## SERVICE INFORMATION NO. SI 42-087

GARMIN – Service Bulletin No. 0823 Rev. B  
ATA-Code: 34-00

**NO.: 0823 Rev B**

**SUBJECT:** GDU 104X CRS/BARO Knob Interference

**Figure 1**

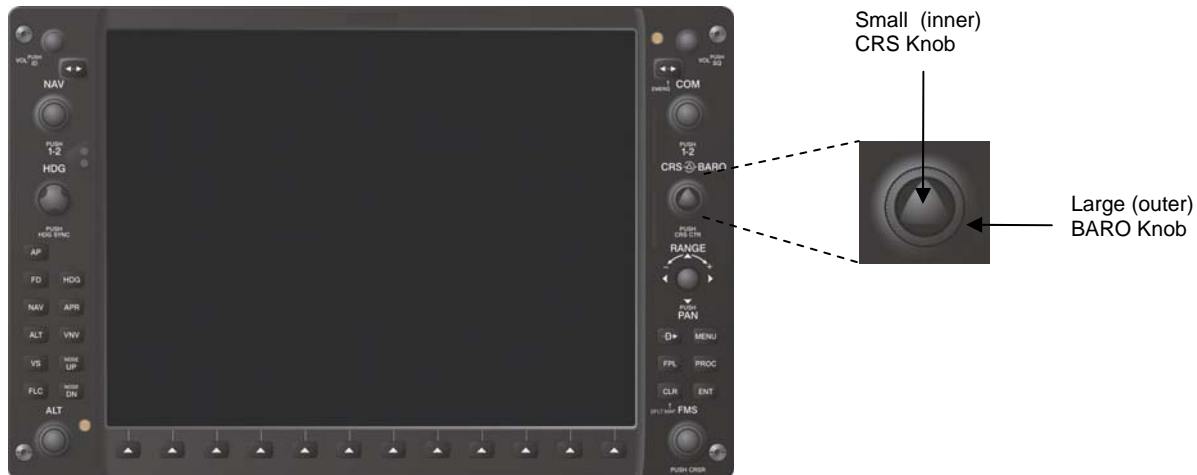
Garmin has identified an issue, whereby the large (outer) BARO knob and the small (inner) CRS knob may interfere with each other.

1. Apply power to the G1000/G900X/G950.
2. Press the CDI softkey on the Primary Flight Display(s) (PFD) to enter VOR mode on the HSI.
3. Rotate the large (outer) BARO knob (refer to Figure 1) a minimum of three complete revolutions in each direction while monitoring the Horizontal Situation Indicator/Digital Course Indicator (refer to Figure 3) on the PFD. If a change in the Horizontal Situation Indicator/Digital Course Indicator is produced while turning the BARO knob proceed to the Modification Instructions.

4. Rotate the small (inner) CRS knob (refer to Figure 1) a minimum of three complete revolutions in each direction while monitoring the Barometric Altimeter Setting (refer to Figure 3) on the PFD. If a change in the Barometric Altimeter Setting is produced while turning the CRS knob proceed to the Modification Instructions.
5. Repeat Steps 3 and 4 for each affected GDU.

**Figure 4**

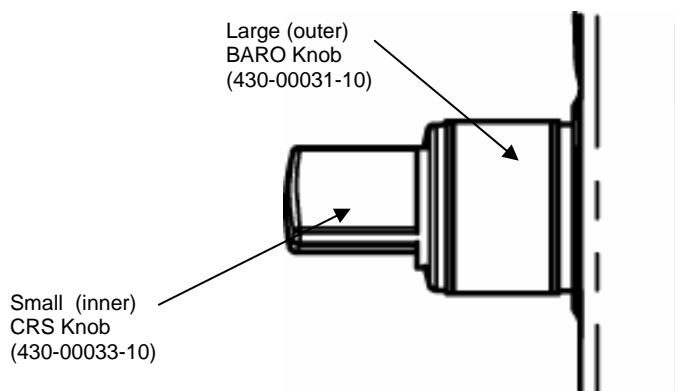
5. Grasp the large (outer) BARO knob (insuring proper orientation) and place it over the shaft.
6. Align the flat side of the knob insert with the flat side of the shaft.
7. Press down firmly to ensure knob is completely seated, refer to Figure 4.
8. Grasp the small (inner) CRS knob (insuring proper orientation) and place it over the shaft.
9. Align the flat side of the knob insert with the flat side of the shaft.
10. Press down firmly to ensure knob is completely seated, refer to Figure 4.
11. Perform the CRS/BARO Knob Interference Test (contained in the TESTING PROCEDURE section) again to confirm there is no interference.
12. Accomplish aircraft logbook entry to return aircraft to service in compliance with this service bulletin.
